# Additional Information

## Mack Energy Glacier SWD-2617

- E-mail documenting lack of data for FSP analysis, historical well plugging details and unavailability of Devonian water sample
- Induced Seismicity Report without FSP analysis

Subject: **Mack Energy Corporation**  
**Glacier SWD #1 - Seismic Potential Letter**

**Attachment 2**  
**Seismic Event Map**

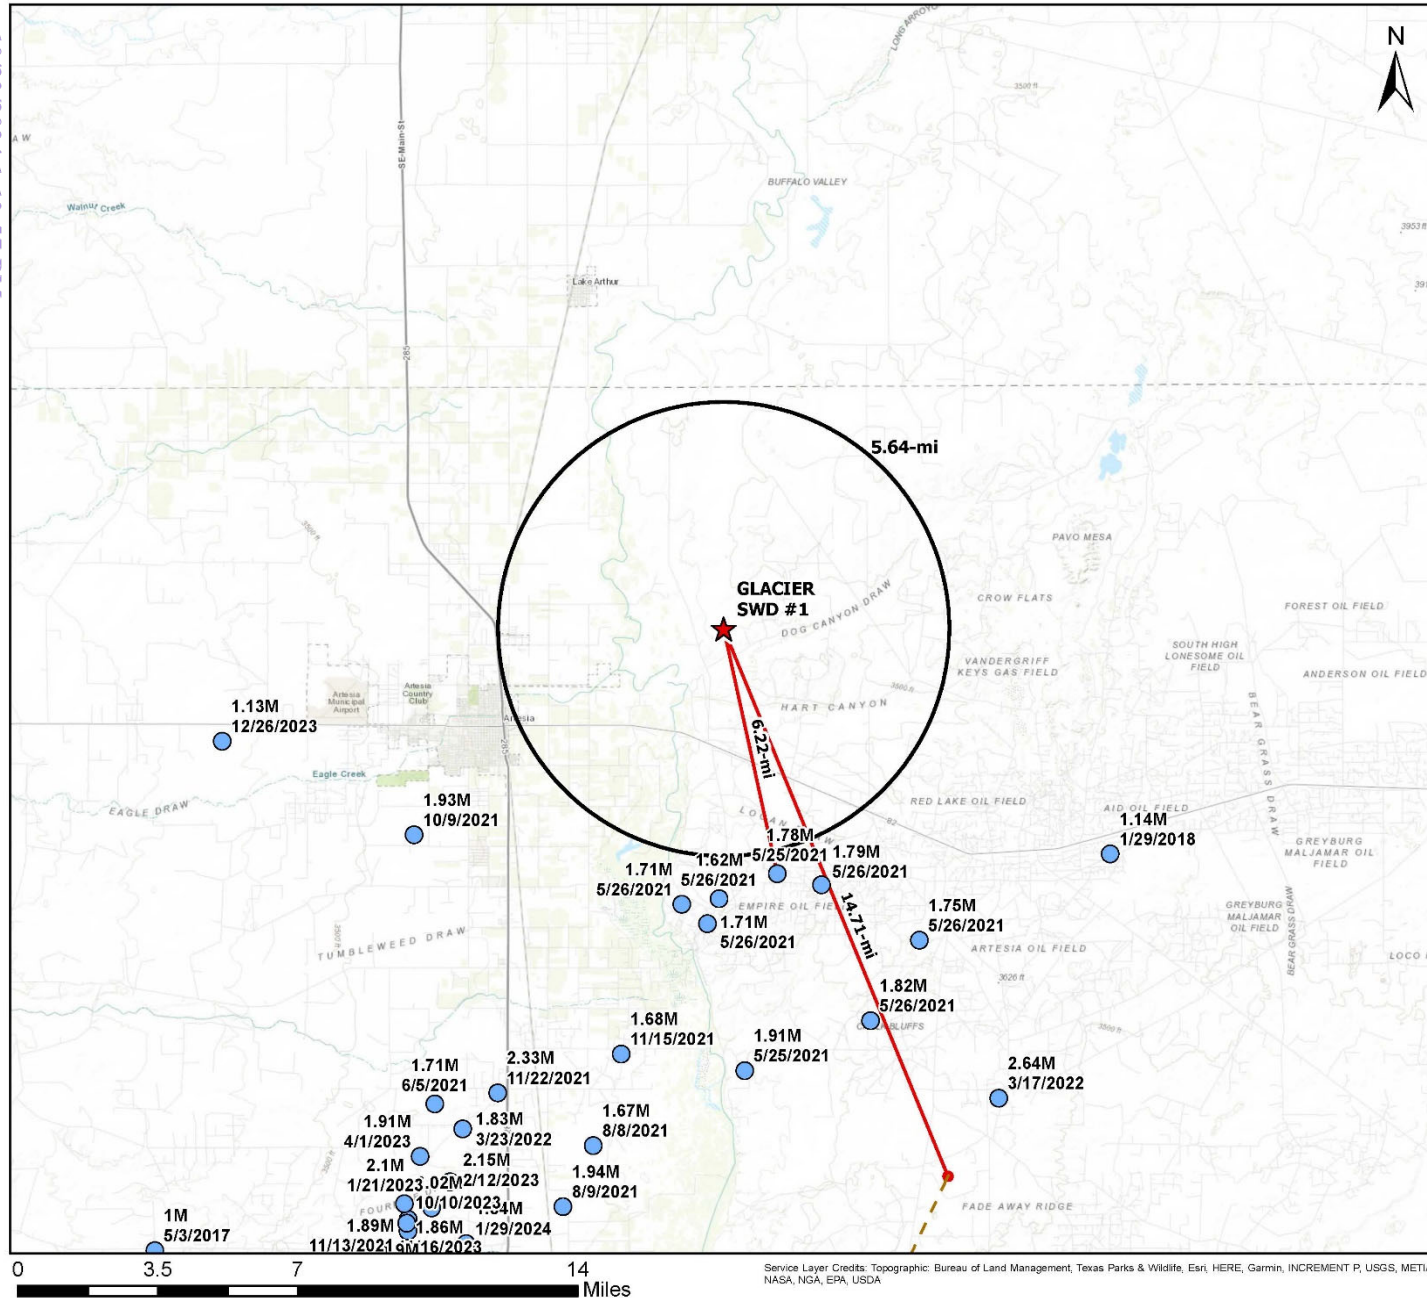
The closest recorded seismic event was a M1.78 that occurred on May 25, 2021, and was located approximately 6.22 miles south of the Subject SWD (see **Attachment 2**). **Per the USGS earthquake catalog, no seismic events M2.5 or greater have been recorded within 10 miles of the proposed SWD.**

Fault data from United States Geological Survey (USGS) and the Texas Bureau of Economic Geology (BEG)<sup>2</sup> indicates that the closest known fault is located approximately 14.71 miles south/southeast of the Subject Well (see **Attachment 2**). This identified fault is within the Precambrian basement, which is approximately 3,220 feet below the proposed injection interval.<sup>3</sup> **No Precambrian basement faults were identified within two miles of the subject well, or within the 100 square mile area of review centered on the subject well.** A map of the seismic events and faults within 9.08 km of the Subject SWD is included as **Attachment 2**.
